**East Malling & Larkfield TM/12/03326/FL
East Malling**

Demolition of existing industrial buildings and construction of 10 houses with associated garages, parking, roadways and landscaping at Blacklands Mill Street East Malling West Malling Kent for Ms Annette Barnes

**East Malling & Larkfield TM/13/00551/FL
East Malling**

Replacement of self-supporting fence situated behind existing ragstone boundary wall. In addition, replacement of small section of fencing with ragstone walling in keeping with adjoining wall fronting on house at Ivy House Farm 42 Chapel Street East Malling West Malling Kent ME19 6AP for Mr Jonathan Colvile

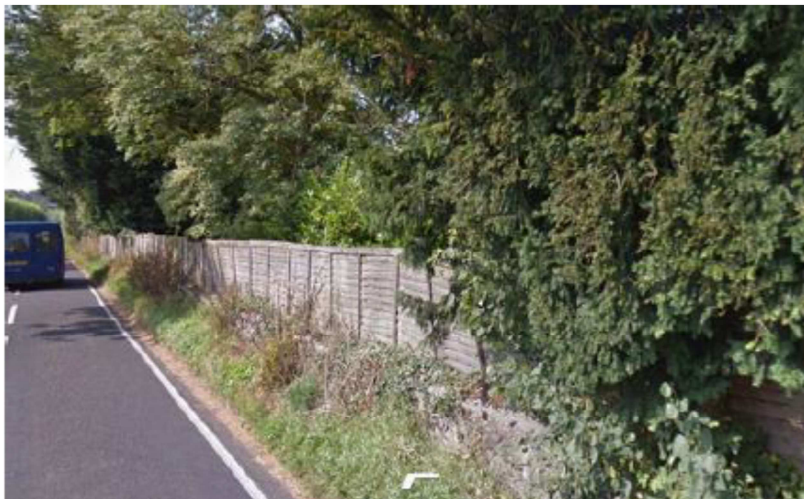
I am aware that you have received several pictures of the fence and its impact on the Conservation Area as well as the neighboring properties but to ensure that all pictures are available for you and the Committee I submit the following: -

This photograph was taken prior to the work and clearly shows the 6ft wide panels, if you scale these the height is less than 2m as stated in the application
